GOVERNMENT OF THE DISTRICT OF COLUMBIA
DEPARTMENT OF TRANSPORTATION

MEMORANDUM

SUBJECT: DDOT Review of BZA Case #18590, Woodbridge Library, 1801 Rhode Island Ave, NE
(Square 4210, Lot 825)

Figure 1 Weekday On-Street Parking

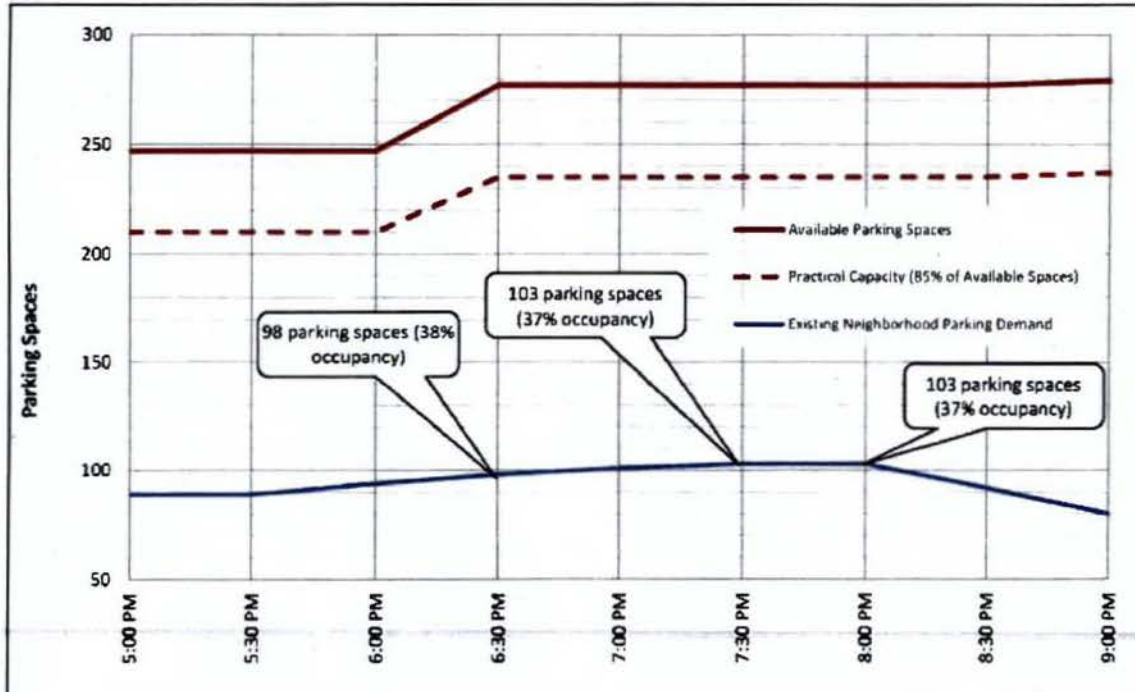
The Applicant conducted a curbside parking utilization study in an area surrounding the site. The study showed a large supply, about 250 spaces on weekdays and 275 spaces on weekends, of curbside parking within two blocks of the site. The vast majority of the on-street parking spaces are unregulated spaces. Peak parking demand for the entire neighborhood was observed to be at 6:00 PM when about 150 of the 250 on-street parking spaces were unoccupied. Saturday peak parking demand occurred at 2:30 PM when about 165 of the 275 on-street parking spaces were unoccupied. Both counts of parking availability are inclusive of parking generated by the existing library.
